ANP-2843Q1NP
Revision 0

LaSalle Unit 2 Nuclear Power Station Spent Fuel Storage Pool Criticality Safety Analysis with Neutron Absorbing Inserts and Without Boraflex - RAIs

June 2010

AREVA NP Inc.

Figure RAI-40.1: Evaluation for EALF Trend

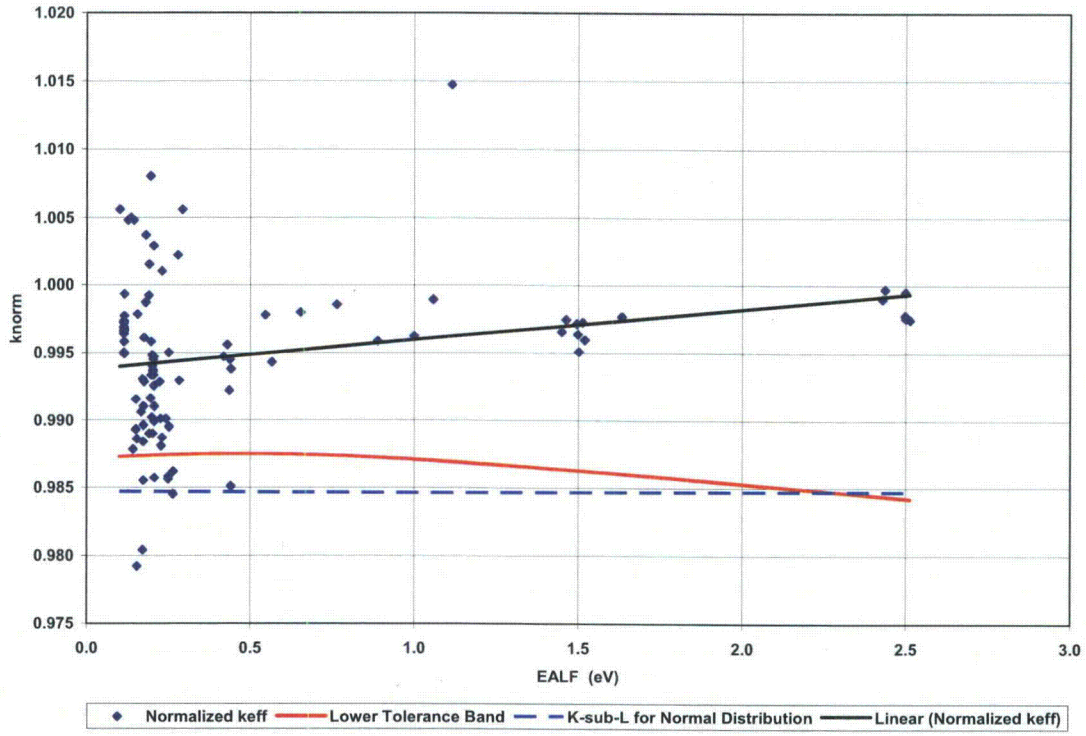
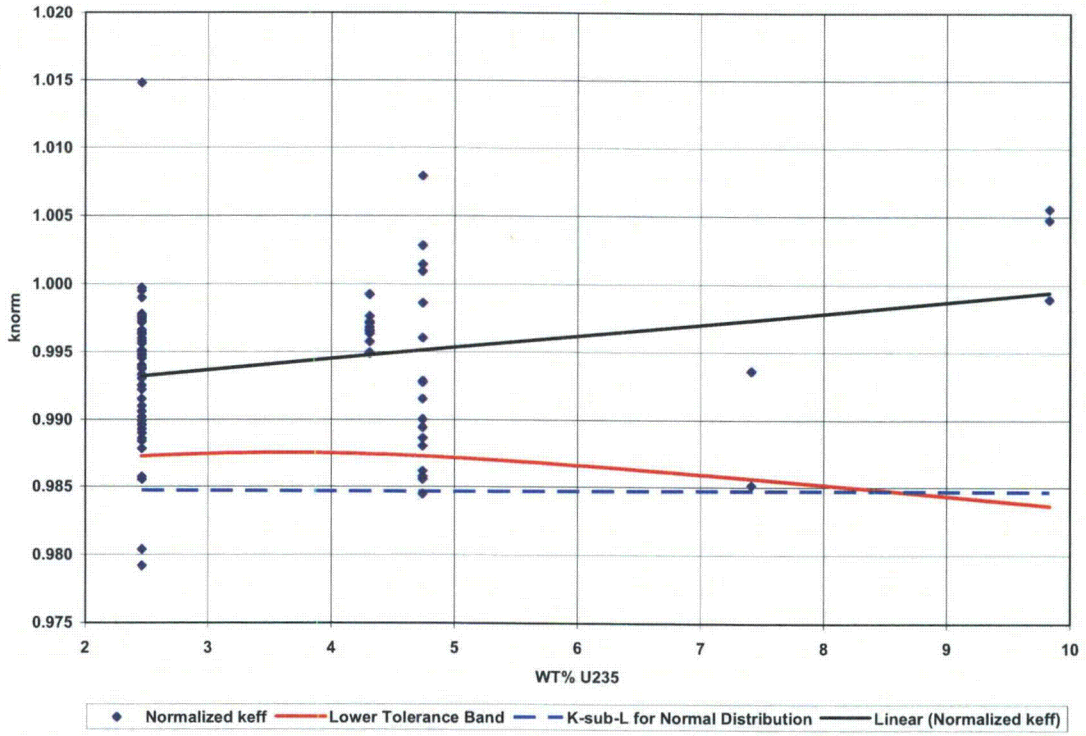
Describe the statistical method and acceptance/rejection criteria used for determining that there are no trends in the data in Table C.5 in ANP-2843(P) (proprietary). Provide a reference describing the statistical method. While the ITI>t and the p-values are low for EALF and enrichment trends, it is not clear that no valid trends exist.

Reference C.8 recommends the use of the Anderson-Darling test to verify a data sample is distributed normally (see pp. 372 – 373 of Reference C.8). Anderson-Darling test results obtained for the standardized residuals of the EALF and enrichment trends were A* = 1.28 and A* = 1.15, respectively; both results exceed the critical value (A* = 0.752) for a significance level of 5% (α = 0.05), thus the null hypothesis of normality is rejected. While the evidence must be weighed subjectively, AREVA's conclusion is that there are no statistically significant or valid trends affecting the criticality bias evaluation. This same conclusion is documented in several previously approved licensing submittals. However, if the evidence of trends for EALF and enrichment were accepted, lower tolerance bands could be calculated, which would appear as shown in the following figures. In comparison to the K_L = 0.9847 limit that was determined based on a normal distribution of data with no significant trends (see RAI-39), the lower tolerance limit is conservatively bounding for all but the highest end of the ranges. At the high
